Ford Motor Company  
 P. O. Box 1904  
 Dearborn, Michigan 48121

**SUBJECT:** **Customer Satisfaction Program 18N03 - Supplement #2**  
 Certain 2015-2018 Model Year F-150 and 2017-2018 Model Year F-250-F-550  
 Vehicles - Door Latch Freezing Concerns

**New! REASON FOR THIS SUPPLEMENT**

FIGURE 1

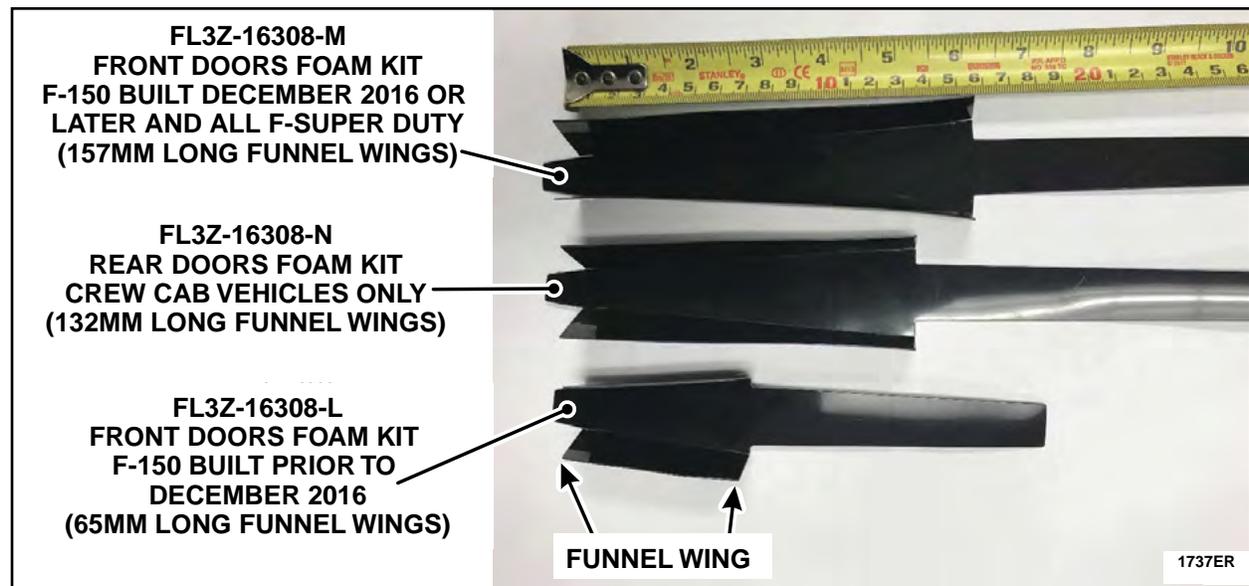
Some of the door foam kits were packaged with incorrect size door glass run funnels. Dealers are to measure the door glass run funnel wings using the measurement guide below. If a door foam kit is found to have incorrect size door glass run funnels the correct size door glass run funnels can be removed from another kit, and that additional kit the door glass run funnels were removed from can also be claimed with this repair. All unused parts from the additional kit can be scrapped.

**NOTE:** This packaging error caused rear doors foam kit FL3Z-16308-N to be incorrectly packaged with door glass run funnels from front doors foam kits FL3Z-16308-M. Conversely, the front doors foam kits FL3Z-16308-M were also incorrectly packaged with door glass run funnels from rear doors foam kit FL3Z-16308-N. If foam kits FL3Z-16308-M or FL3Z-16308-N are found to have incorrect funnels the correct funnels can likely be found in the other kit.

1. Verify the correct door glass funnels are being installed by measuring the funnel wings as shown in Figure 1.

**NOTE:** Funnel modification is not advised.
